City Planning Commission Meeting – January 27, 2015

CONSIDERATION – SUBDIVISION DOCKET – 170/14

Applicant: 1013-17 Austerlitz, LLC & 1016 Gen. Taylor, LLC

Proposal: Subdivision of Lots 5, Part of 5 and A into lots A1 and 5A.

A Resubdivision of Lots 5, "A", and Pt. 5 into Lots A1 & 5A.

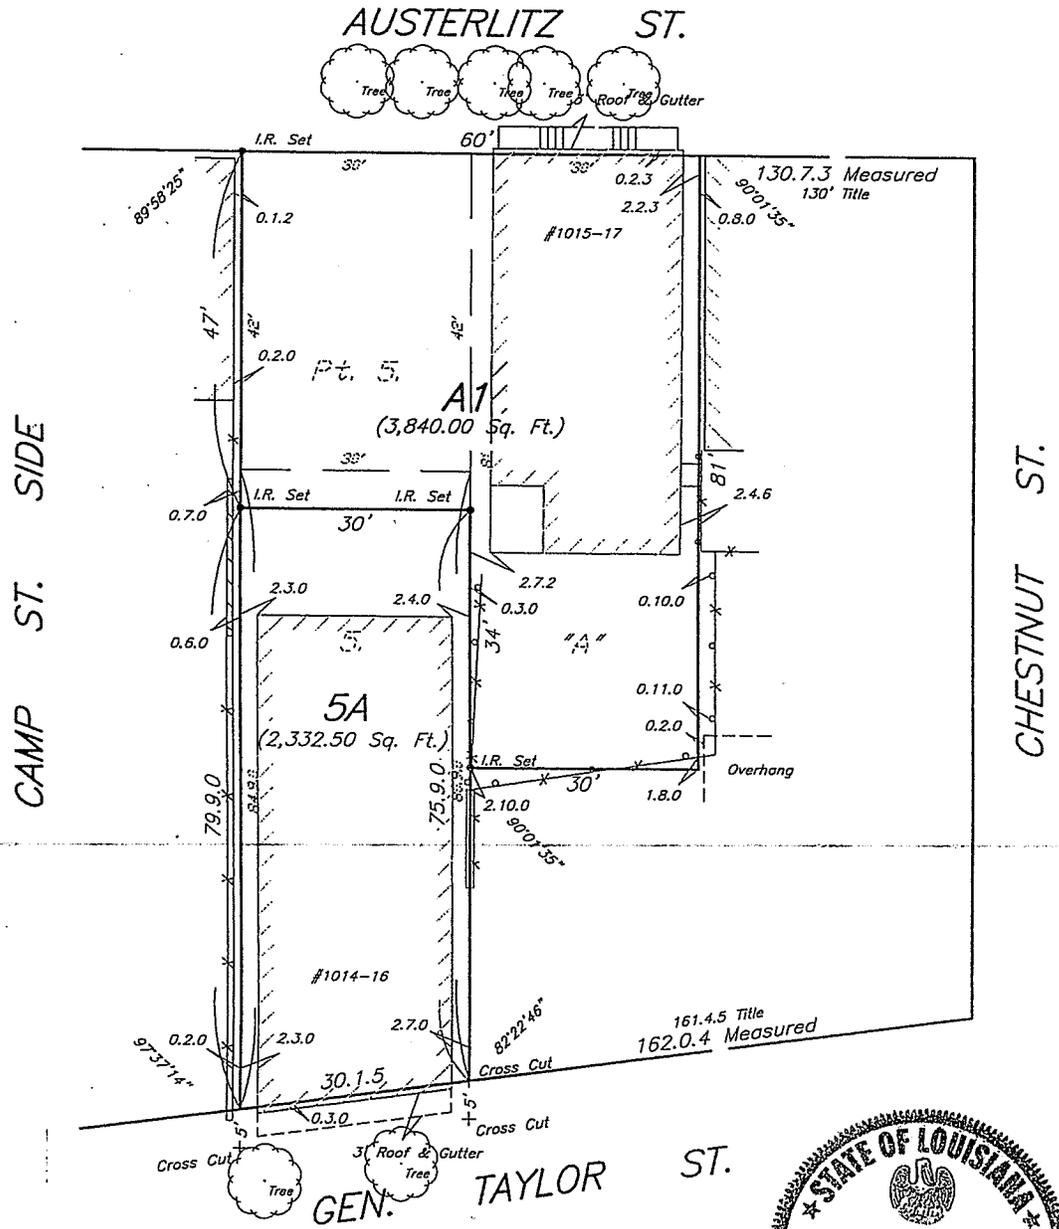
Lots: **Lot 5A** would measure 30' in width, 75'-9" to 79'-9" in depth, and will contain an area of 2,332.5 square feet. The depth of the existing Lot 5 will be reduced by 5 feet and its area by 150 square feet. This reduction in lot depth will increase the amount of non-compliances for this already substandard lot in terms of lot depth, lot area and rear yard depth. These reductions will require variances from the Board of Zoning Adjustments (BZA).

The proposed resubdivision will combine existing Lot A and Pt.5 into a new Lot A1. The proposed Lot A1 will also get an additional 5 x 30 foot area carved out from the rear of the existing Lot 5. This reduction will further decrease the lot area, lot depth and the depth of the rear yard for the existing Lot 5, therefore increasing the non-conformances with the requirements of the Comprehensive Zoning Ordinance. For a resubdivision to be approved as proposed, variances for the insufficient lot depth, rear yard depth and lot area for Lot 5A will have to be obtained from the Board of Zoning Adjustments.

The proposed Lot A1 will be significantly enlarged through its consolidation with the adjacent Lot Pt.5, without the benefit of a further addition of the portion of a rear yard of Lot 5. Therefore, the staff recommends no reduction in size of the existing Lot 5.

1. The proposed resubdivision will increase the level of nonconformities with the district regulations for Lot 5A that is already substandard in terms of its depth, lot area and rear yard setbacks.
2. The proposed resubdivision will create a lot which is inconsistent with minimum lot sizes established within the immediate neighborhood.
3. The recommended modified approval provides for the larger lot combining Lot Pt5 and Lot A bringing it more in compliance with the required standards, but does not require further reduction in size of Lot 5, which is already deficient in terms of lot depth and lot area.

The staff recommends **MODIFIED APPROVAL** of Subdivision Docket 170/14 to allow consolidation of the existing Lots A and Pt.5 into a single lot of record, subject to five (5) provisos. Lot 5 shall remain unchanged.

1. The applicant shall revise the subdivision plan (survey) to exclude Lot 5 from the request.
